STAFF RECOMMENDATION 2510 Belmont Boulevard January 17, 2018

Application: New construction- addition and outbuilding/detached accessory dwelling unit; Setback determination; Partial demolition

District: Belmont-Hillsboro Neighborhood Conservation Zoning Overlay

Applicant: Martin Wieck, Nine12 Design

Figure 2: Rear addition to be demolished

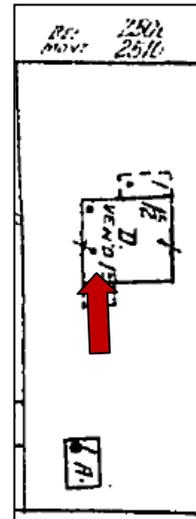
The request includes the demolition of an existing rear addition and uncovered deck (Figure 2). According to the 1957 Sanborn map, the rear addition was originally a covered porch that has since been enclosed (Figure 3). Staff finds that the addition's date of construction, location at the rear of the house, materials, and design do not contribute to the historic character of 2510 Belmont Boulevard or to the Belmont-Hillsboro Neighborhood Conservation Zoning Overlay; therefore, demolition is appropriate.

Staff finds that the proposed alterations are appropriate and meet Section III.B.2 for appropriate demolition and do not meet section III.B.1 for inappropriate demolition.

SITE PLAN
 01

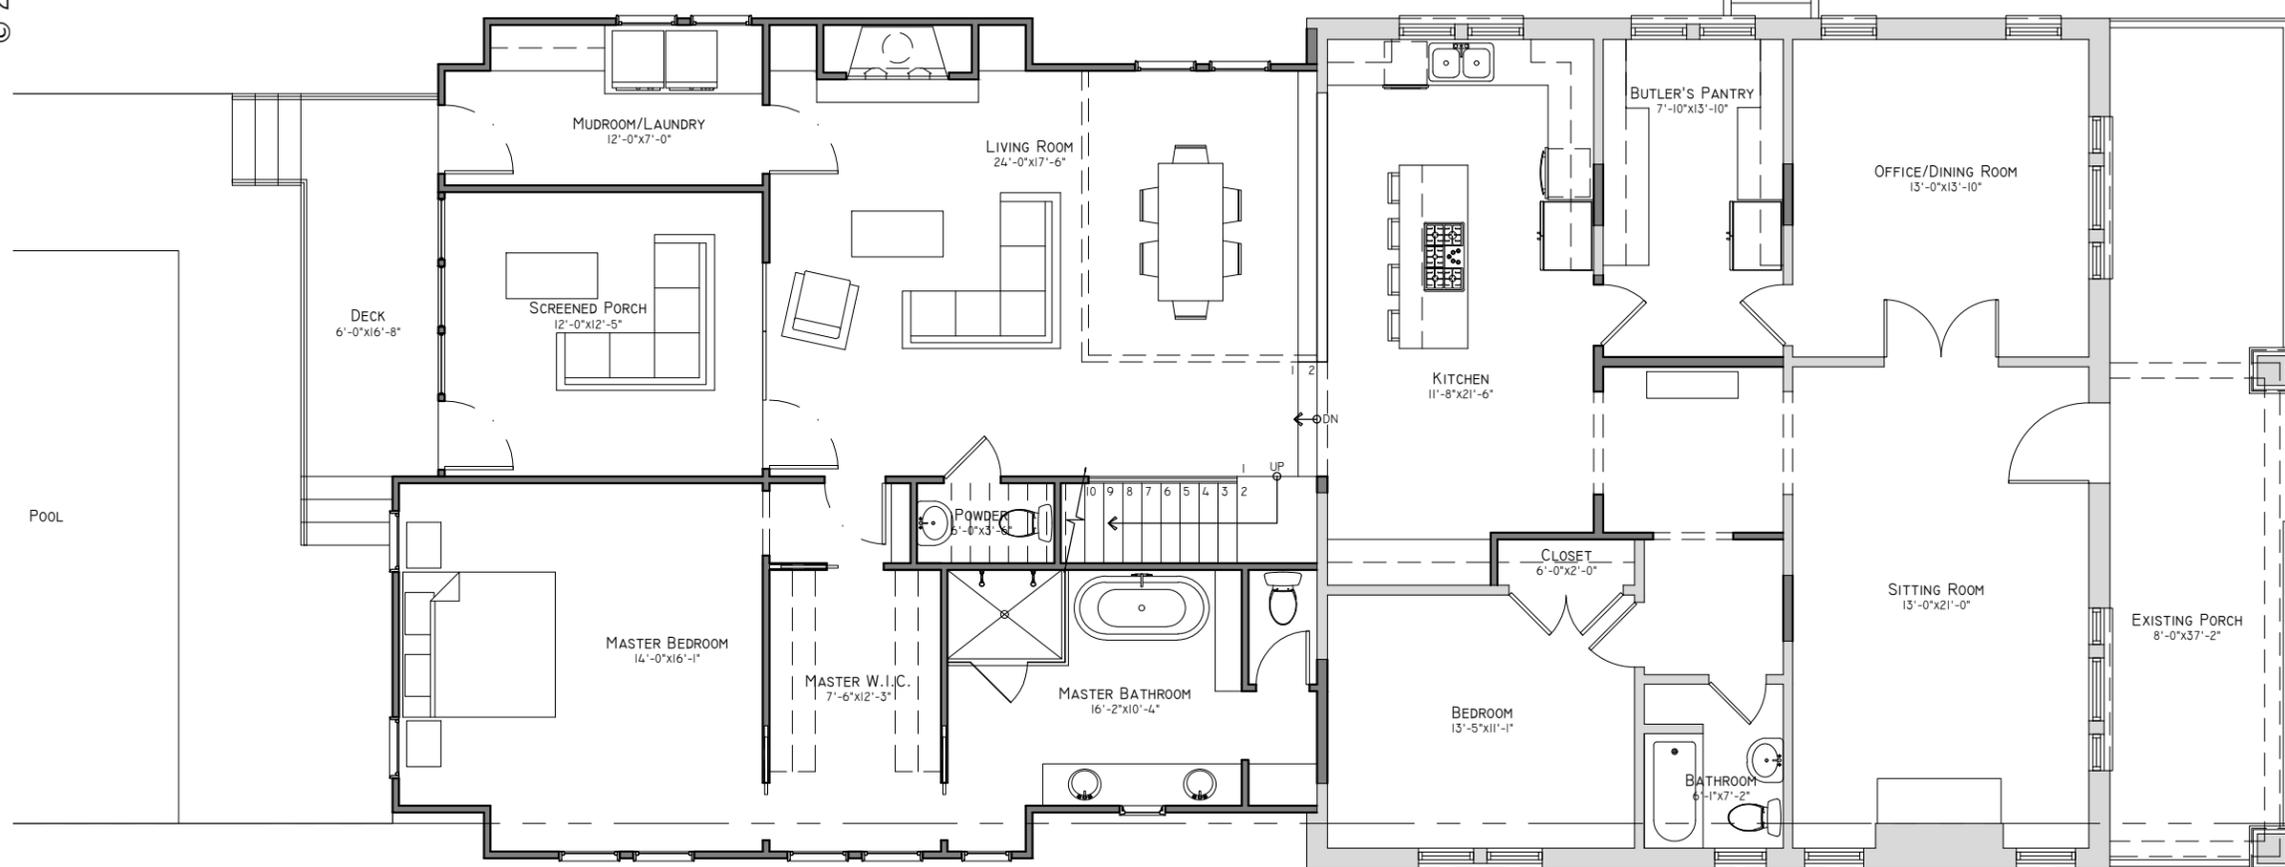
Setbacks: The new addition meets the rear- and right side-setbacks required by the base zoning but does not meet the left-side setback. The applicant requests a setback determination to reduce the left side setback from five feet (5') to three feet, five inches (3'-5"). The addition is located approximately sixty feet, four inches (60'-4") from the rear property line and nine feet, ten inches (9'-10") from the right side property line. On the left side, the addition is approximately three feet, five inches (3'-5") from the

property line. Staff finds that the proposed left side setback is appropriate as it will be no closer to the property line than the existing house.

With approval of the requested left side setback determination, staff finds that the project meets section II.B.1.c.

EXTERIOR
ELEVATION

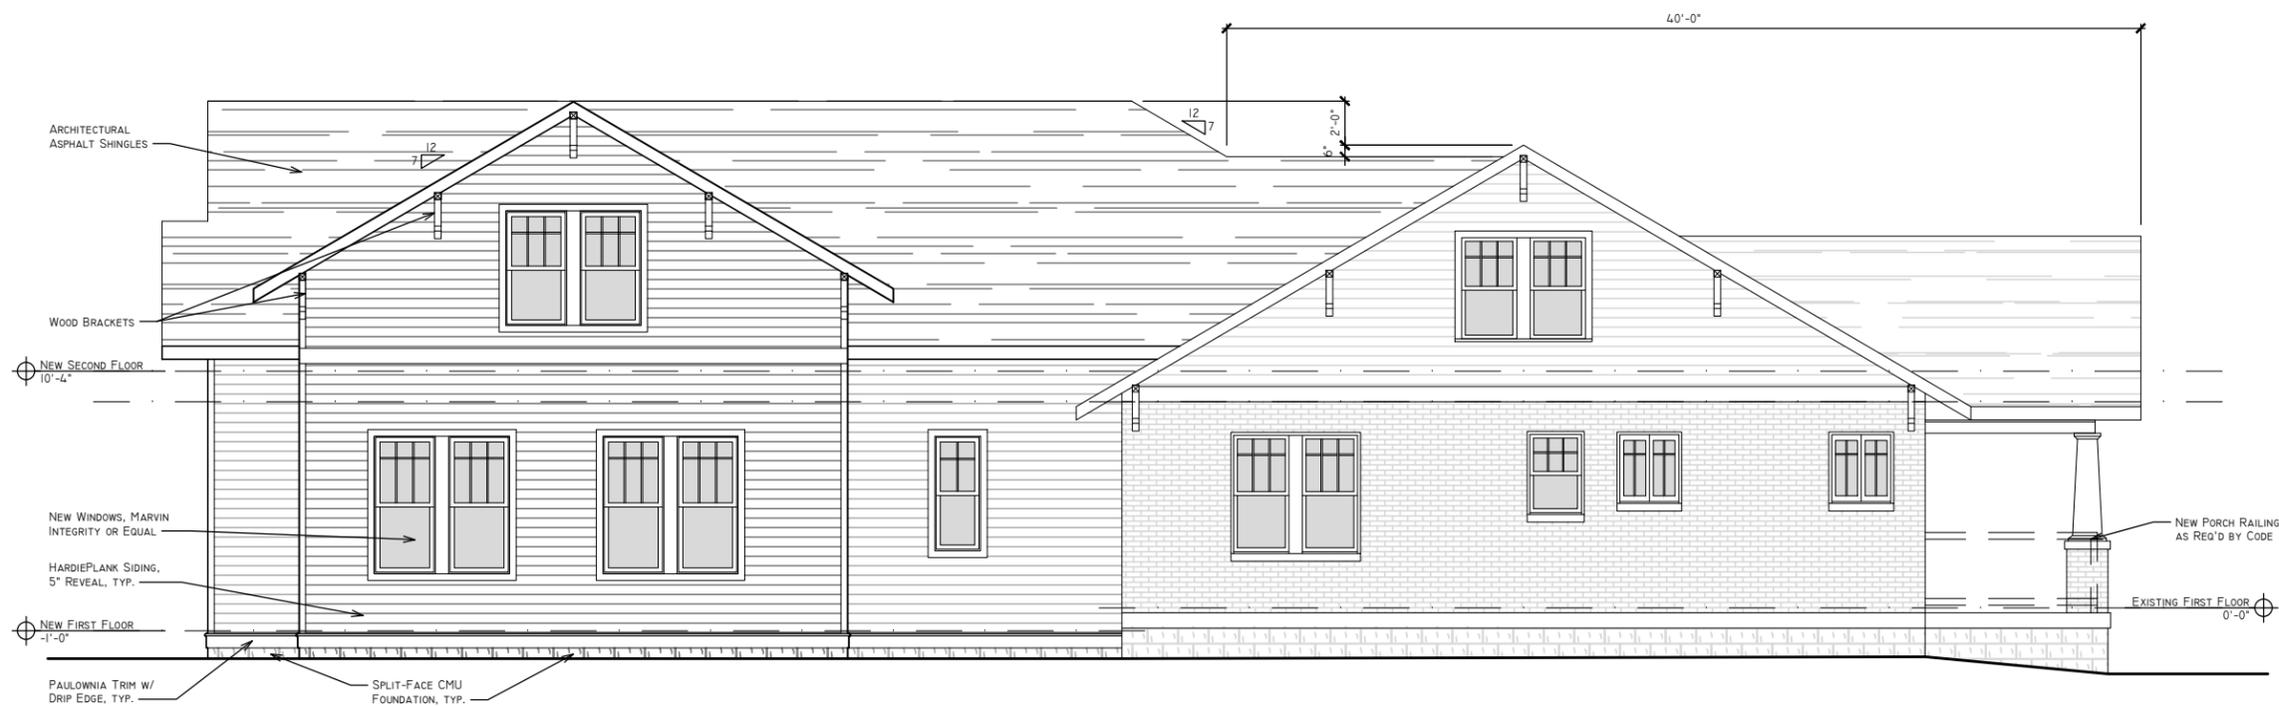
Height & Scale: The proposed additional rear footprint is approximately one thousand, three hundred, sixty-seven square feet (1367 sq. ft.), compared to the existing footprint which is approximately one thousand, four hundred and eighty-seven square feet (1487 sq. ft.). The addition adds forty feet (40') to the depth of the house, which does not more than double the depth of the existing house. The new construction is located at the rear of the historic house, in accordance with design guidelines, and is no wider than the historic house.

The proposed addition adds two feet (2') of additional height to the historic house, and the additional height is located forty feet (40') from the front of the house as required by the design guidelines. Staff finds the additional height to be appropriate since it is no more than two feet (2') of additional height and given the distance behind the house. Since the primary roof form is a side gable, a ridge raise would be possible at this location. The proposed design, however, provides an alternative to a ridge raise which not only maintains the existing ridge line of the historic house but is much less visible from the street.

Roof form: The roof form of the addition is cross gabled, with a 7:12 pitch that complements the existing historic house. Staff finds that the proposed roof form is compatible with the historic house and meets section II.B.1.e.

Proportion and Rhythm of Openings: The windows on the proposed addition are generally twice as tall as they are wide, thereby meeting the historic proportions of openings. There are no large expanses of wall space without a window or door opening. The addition incorporates two skylights on the right side façade. Staff finds that the location of the proposed skylights is appropriate and unlikely to be seen from the street as that portion of the roof sets in two feet (2') and is located more than forty feet (40') from the front of the house. Staff finds the project's proportion and rhythm of openings to meet Section II.B.1.g.

With the condition that staff review and approve the roof color and doors prior to purchase and installation, the project meets section II.B.1.d.
